**CITY OF KELOWNA**  
**MEMORANDUM**

**Date:** October 13, 2020  
**File No.:** Z20-0087  
**To:** Suburban and Rural Planning (BW)  
**From:** Development Engineering Manager (JK)  
**Subject:** 1788 Joe Riche Rd A1 to RU6

**WORKS AND SERVICES REQUIREMENTS**

TITLE: SKETCH PLAN SHOWING PROPOSED SUBDIVISION OF LOT 165, SECTION 18, TOWNSHIP 27, O.D.Y.D., PLAN 24361, EXCEPT PLAN KAP46606 (1788 JOE RICHE ROAD, KELOWNA)

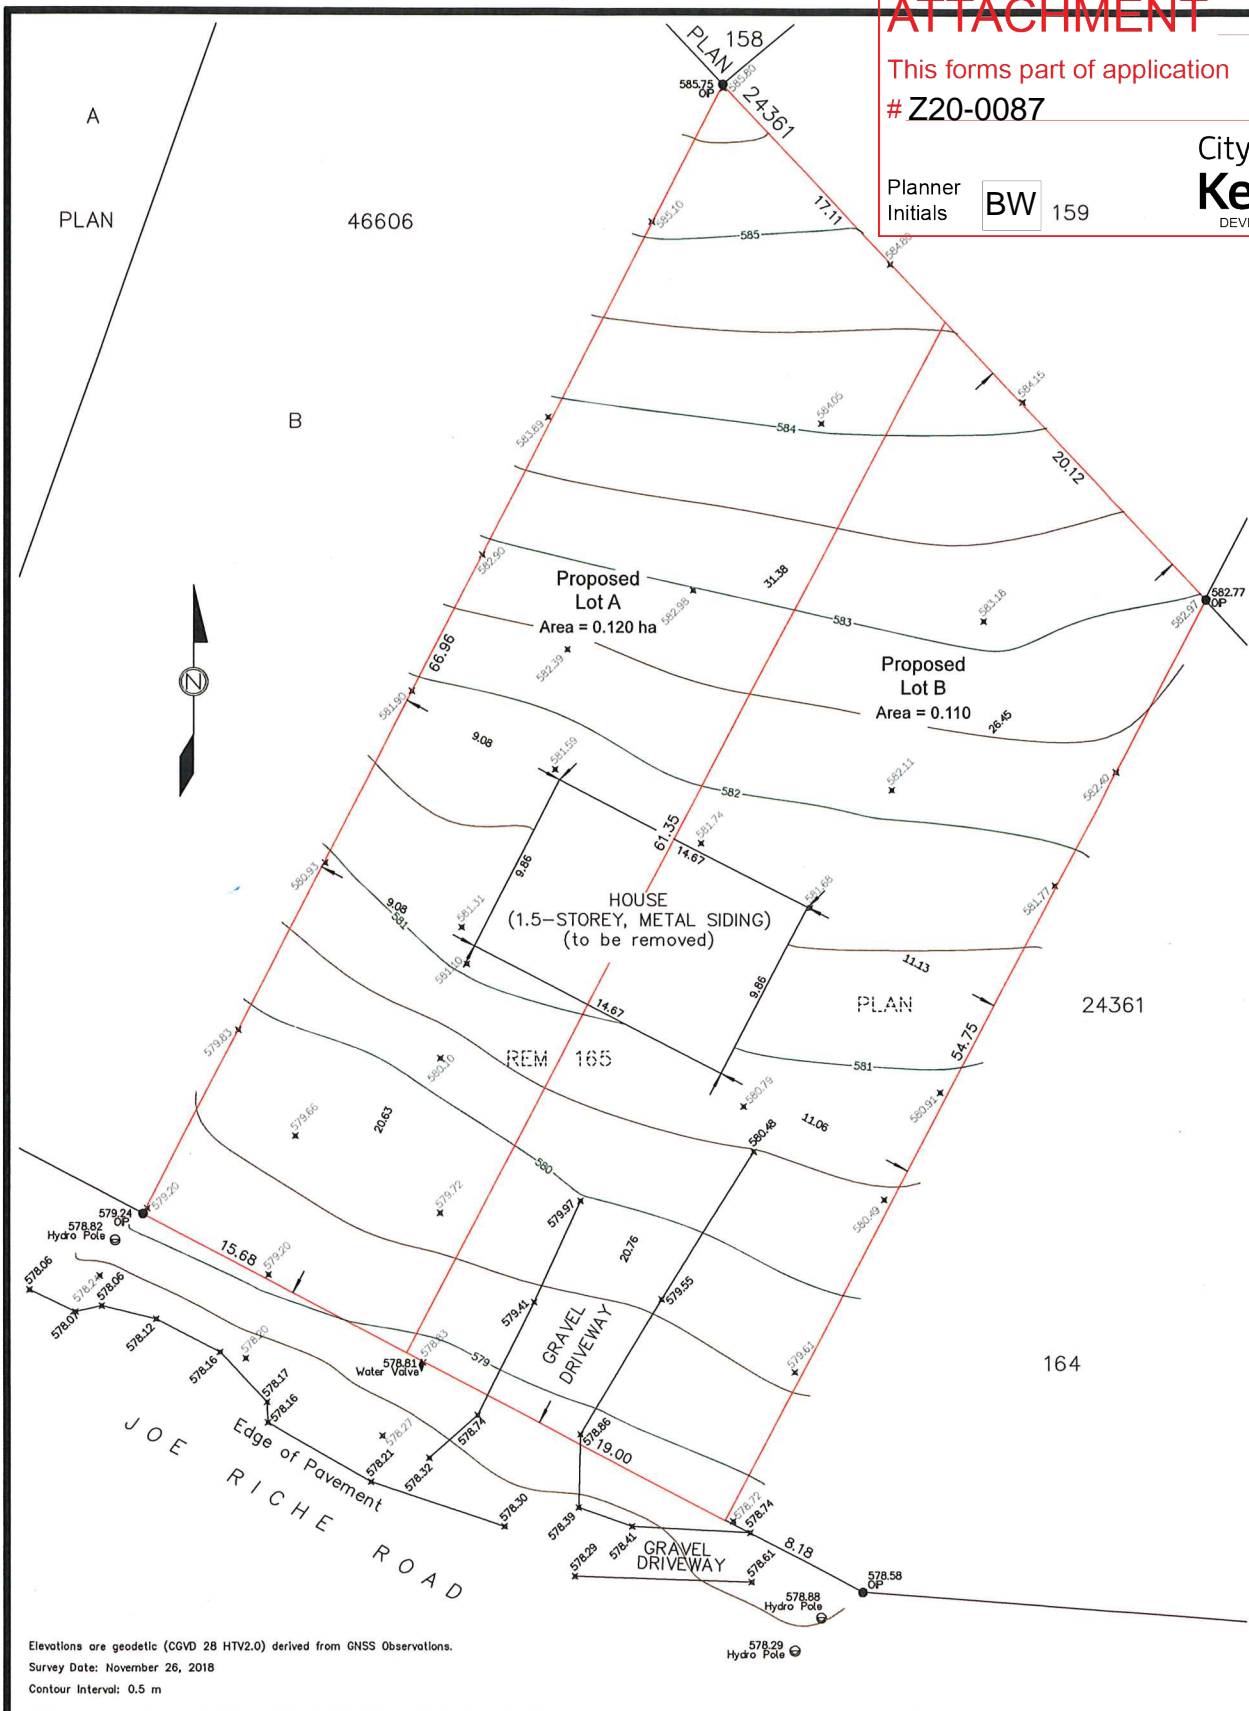
The City's Development Engineering Branch has the following comments and requirements with regard to this application to rezone the subject lot from A1 to RU6 to facilitate a future two lot subdivision. The Development Engineering Technician for this project is Sarah Kelly ([skelly@kelowna.ca](mailto:skelly@kelowna.ca)). The following Works and Services will be a requirement of this development.

- a) Joe Riche Road is designated a local road and will require upgrades along the full frontage including curb and gutter, irrigated landscaped boulevard, driveway let downs, drainage system including catch basin(s) and drywell, pavement removal and replacement, and re-location or adjustment of utility appurtenances if required to accommodate the upgrading construction. A one-time cash payment in lieu of construction must be collected from the applicant for future construction by the City.

- b) Only the service upgrades must be completed at this time. The City wishes to defer the upgrades to Joe Riche Rd fronting this development. Therefore, cash-in-lieu of immediate construction is required, and the City will initiate the work later, on its own construction schedule. The cash-in-lieu amount is determined to be \$41,616 (\$1,200 x 34.68 meters of frontage) not including utility service cost.

- a) As per Bylaw 7900 Schedule 4 Section 4.6, only one driveway access (with a maximum width of 6.0 m) will be permitted per lot.
